## Land Use Application Updates (per 2/28/23 email)

LAND USE APPLICATION  
3/10/2023

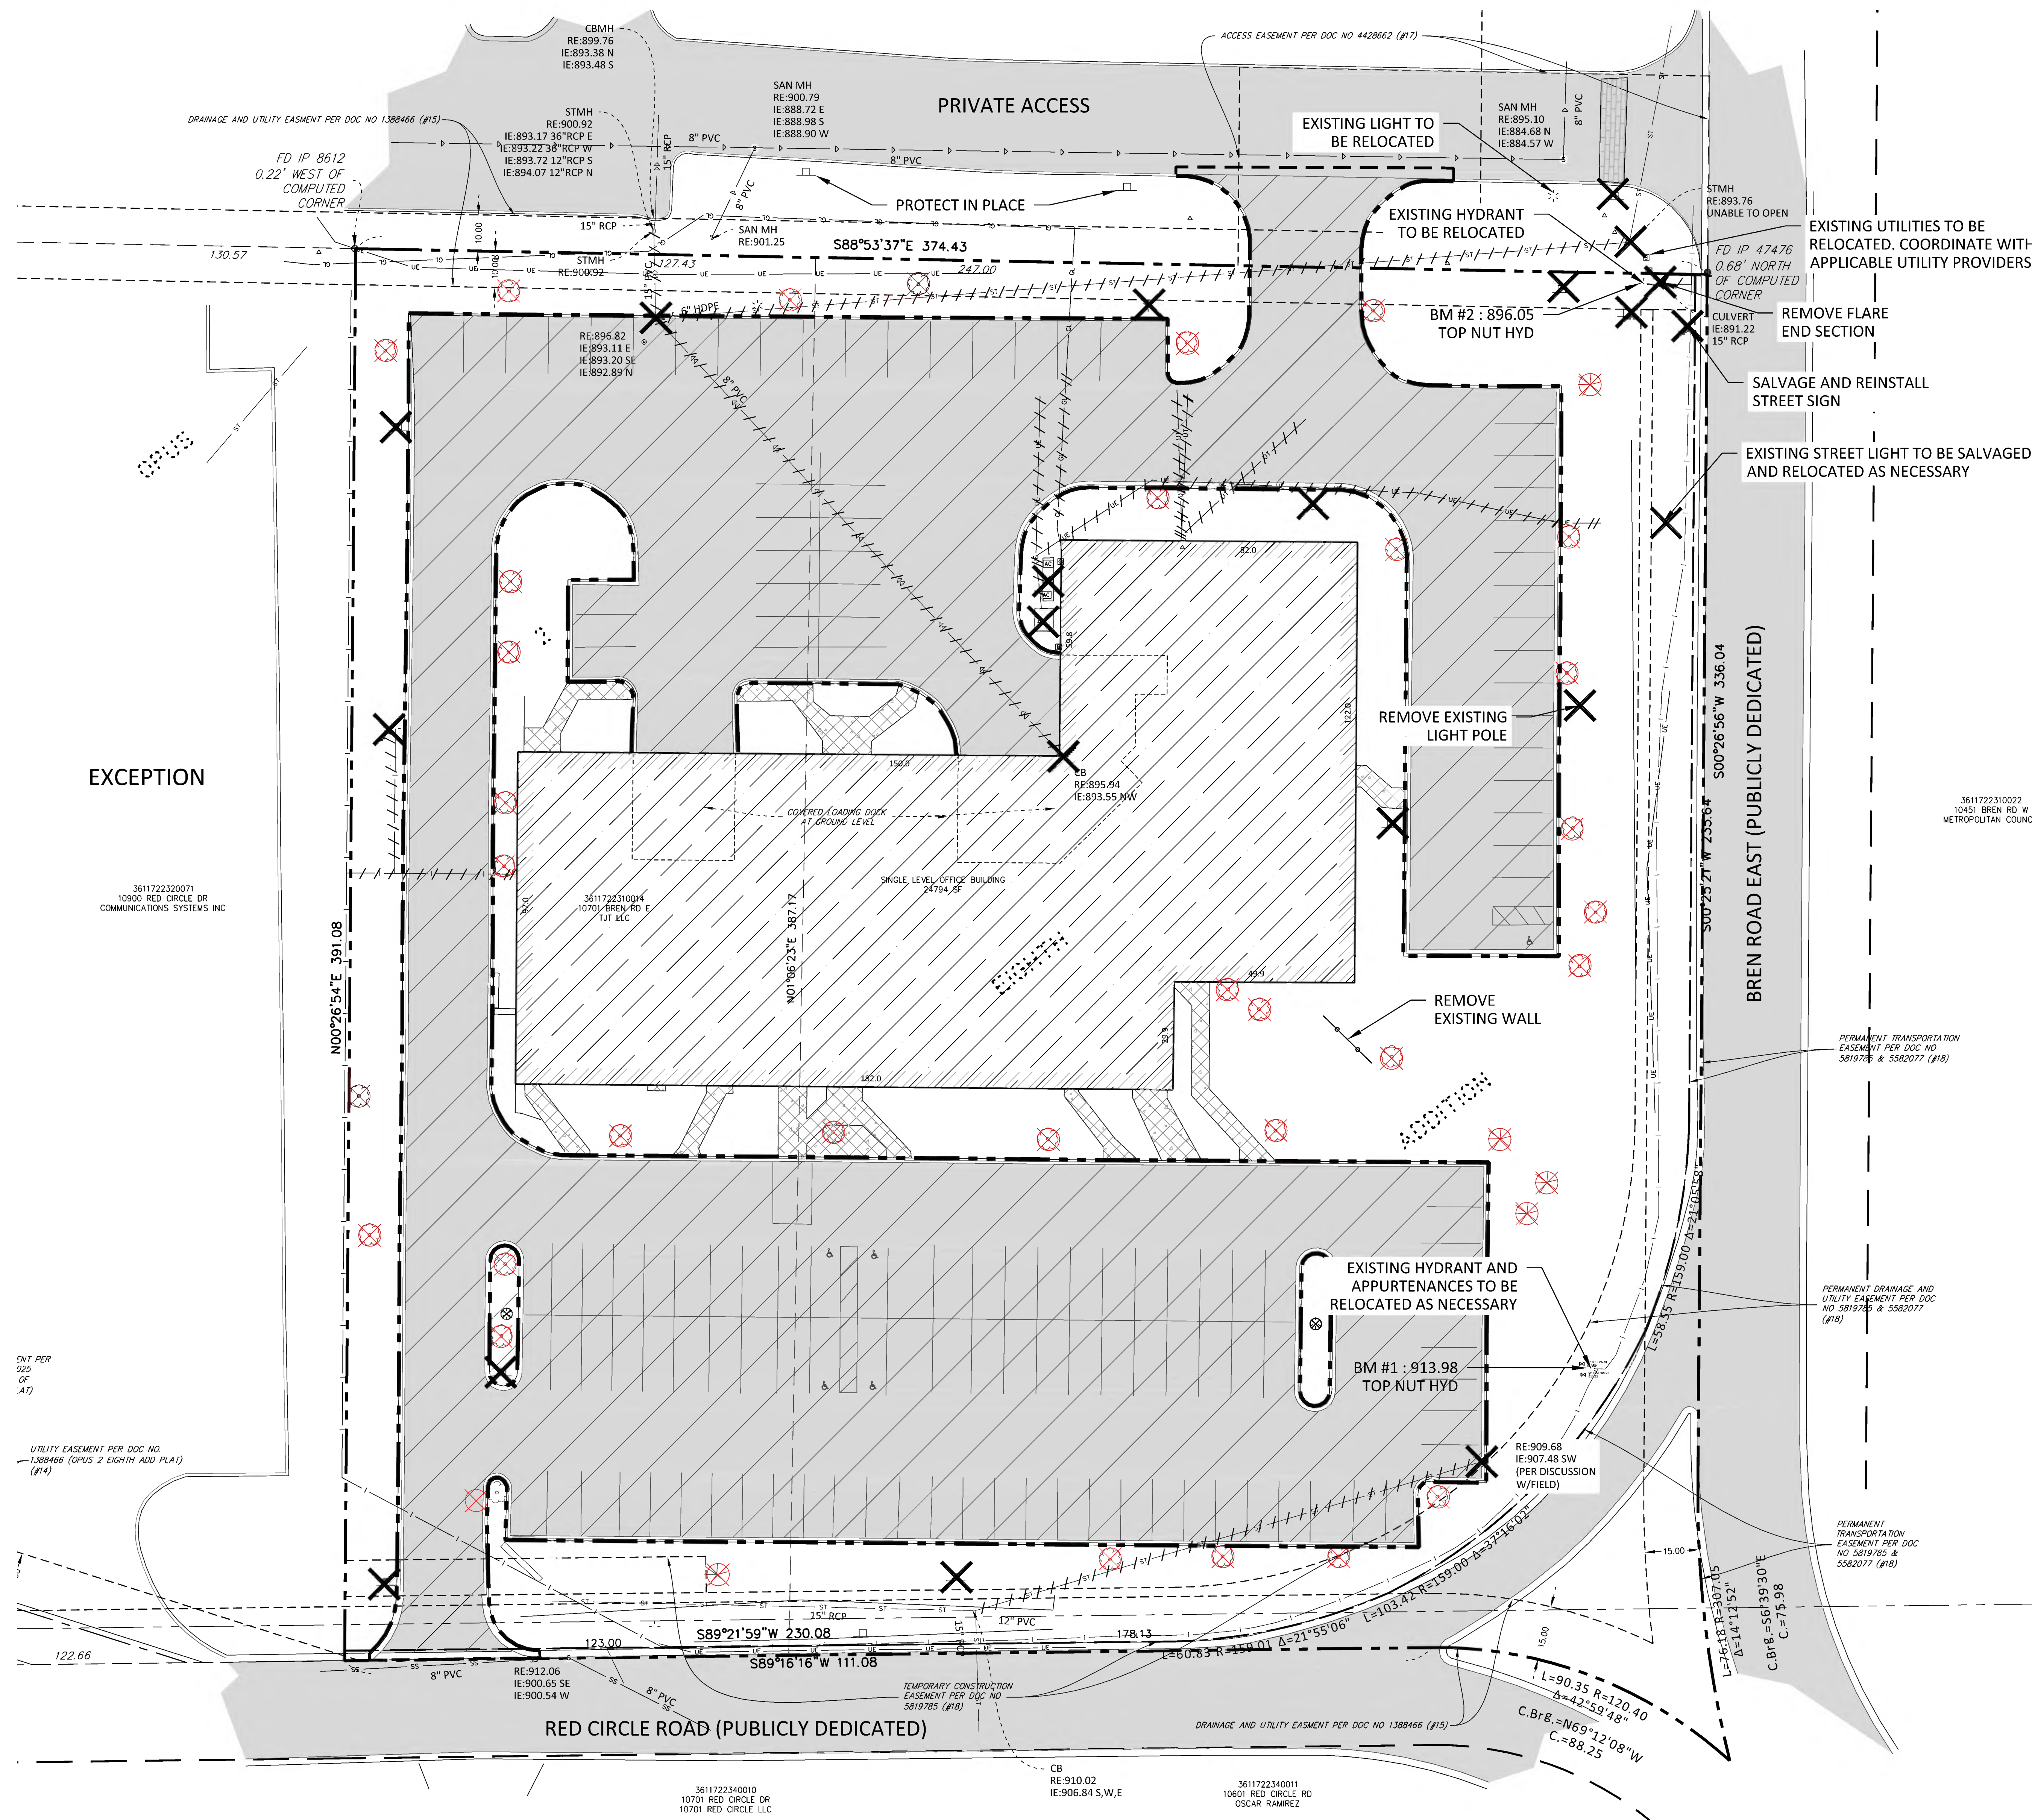
- **Existing conditions survey:** It appears that the trees on the existing conditions survey may not be overlaid correctly. Trees are being shown in the parking lot. These screenshots are of the existing conditions survey and the aerial in the northwest corner of the building. In order to be able to determine if grading tweaks could save onsite trees, as was requested by the council, the survey needs to be accurate. **This has been updated: see sheet C2.01**

GRADING PLAN

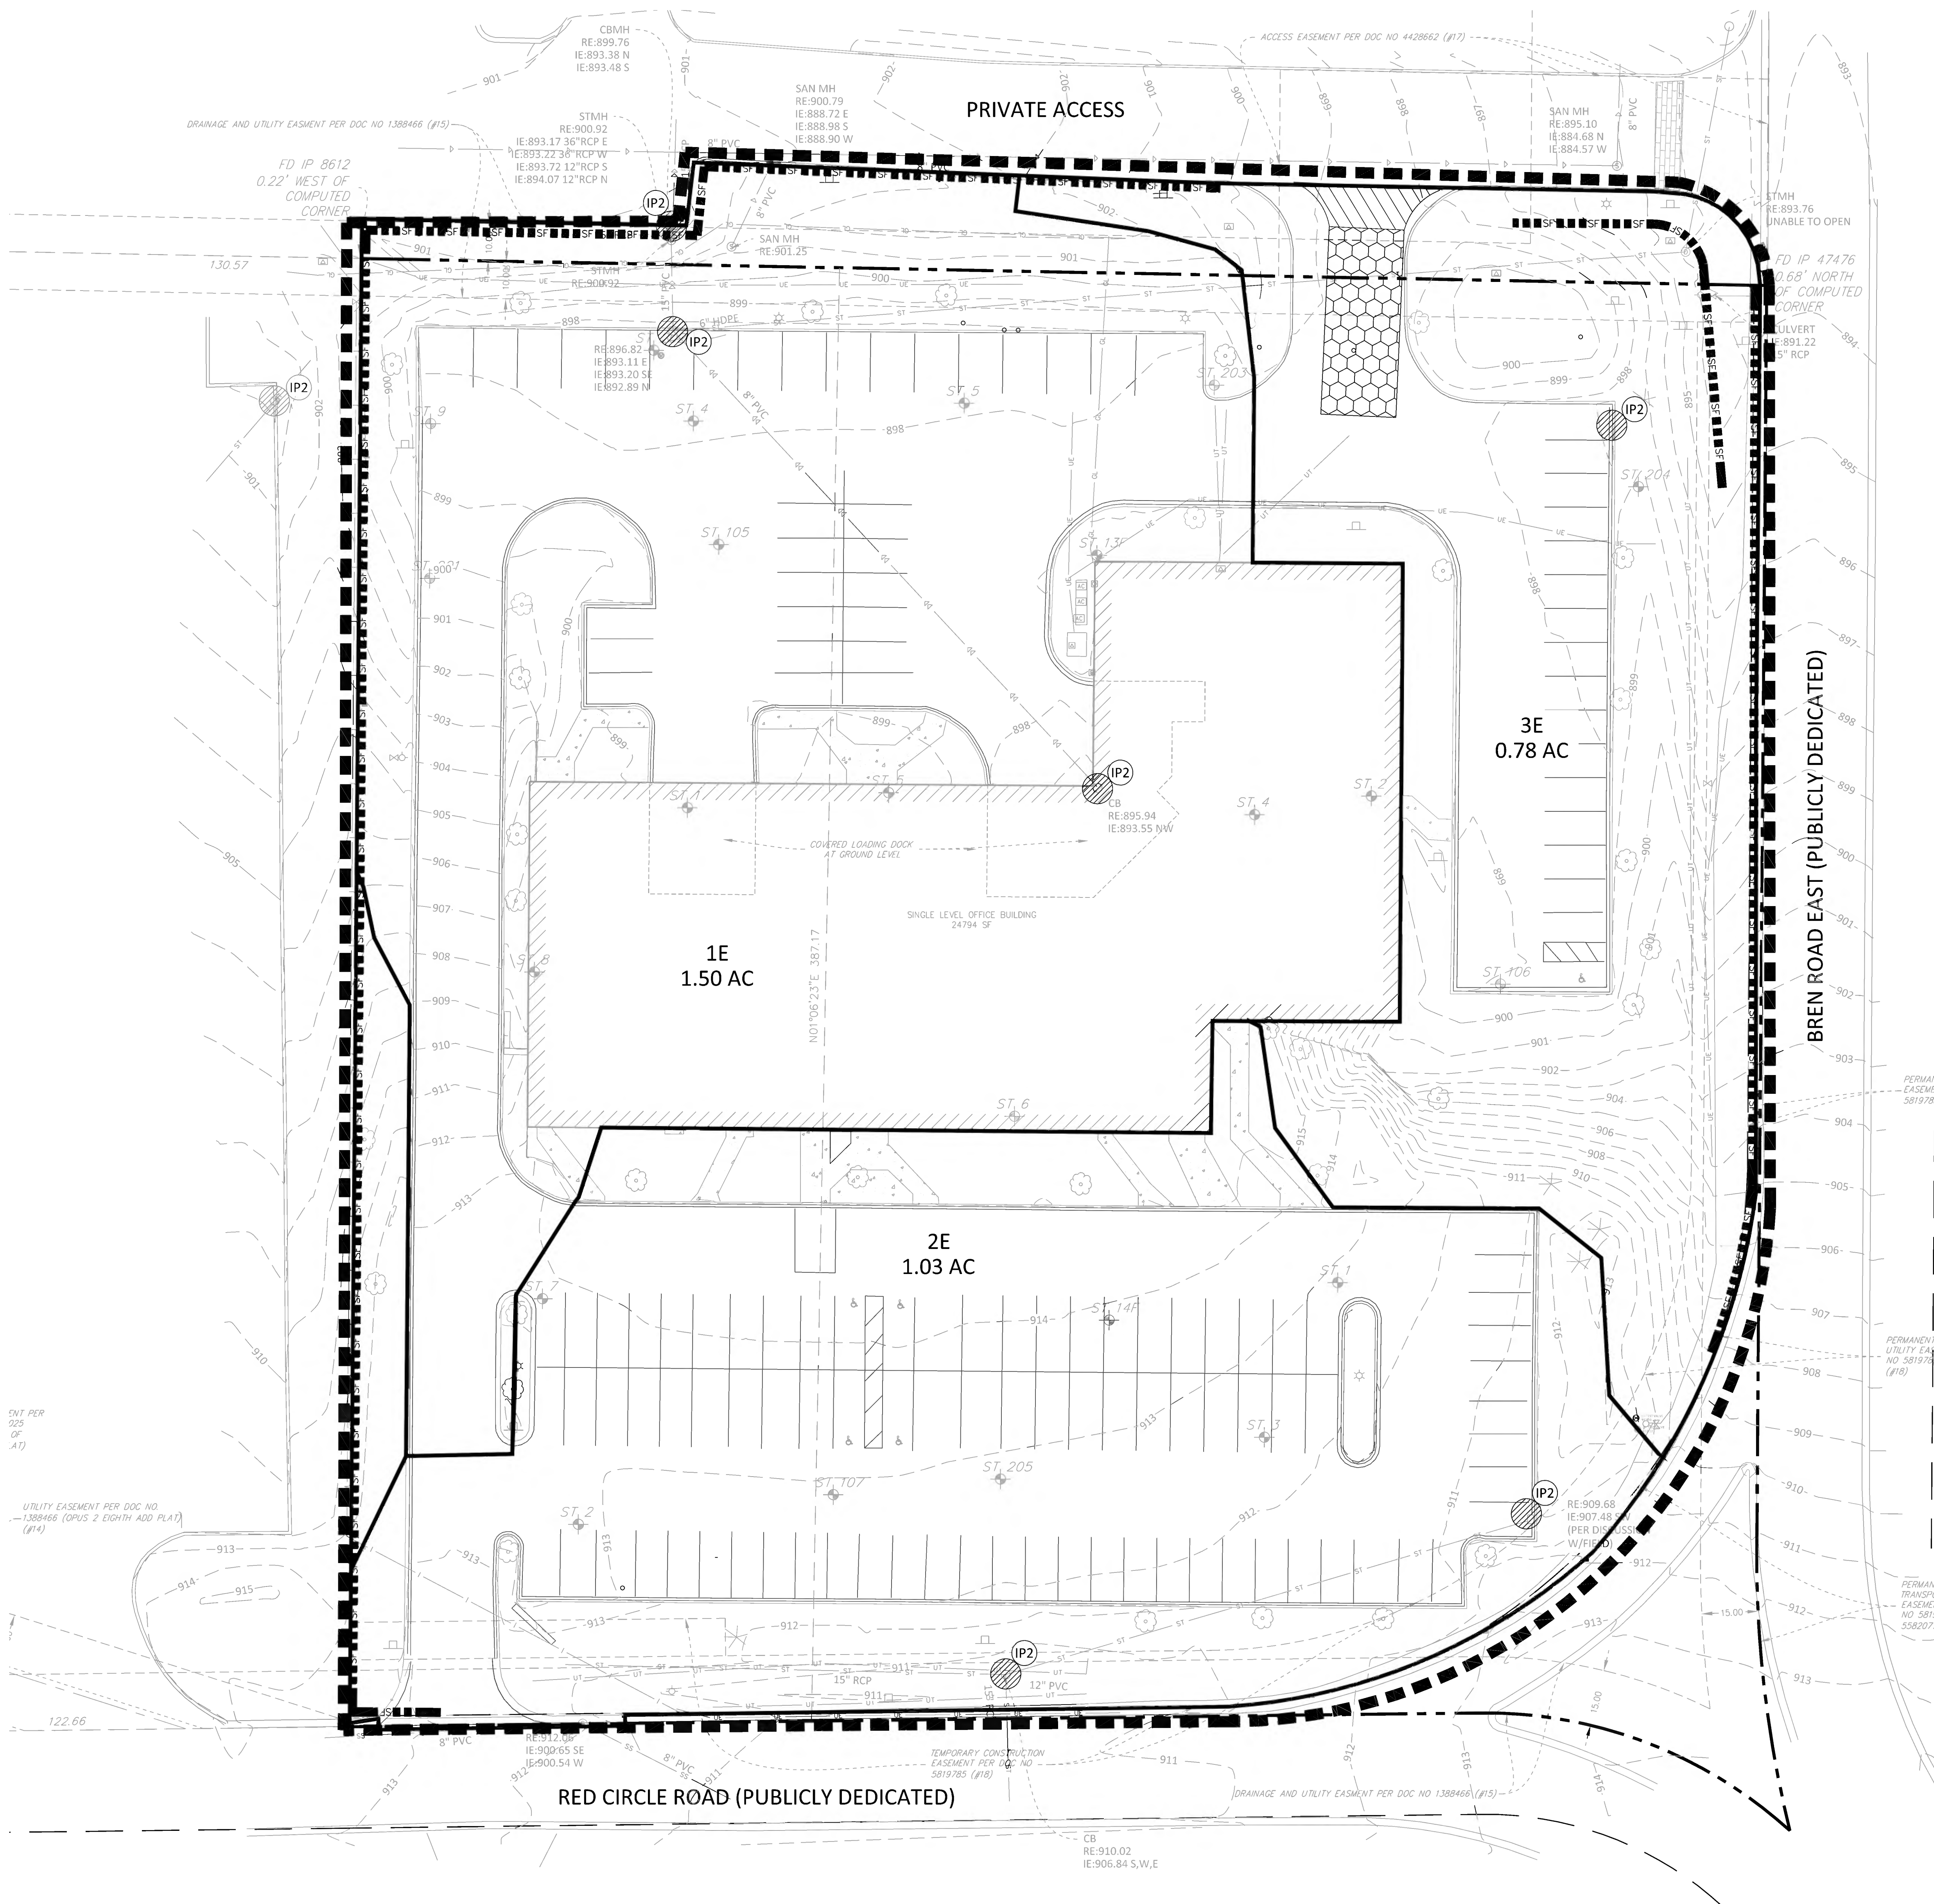
- **Site grading:** The plans must account for the existing drainage and drains to the site as the "ditch" is being removed. More information will be given on this during the meeting. This swale has been reintroduced in the boulevard between the sidewalk and the street along Bren Road. See sheet: C4.01
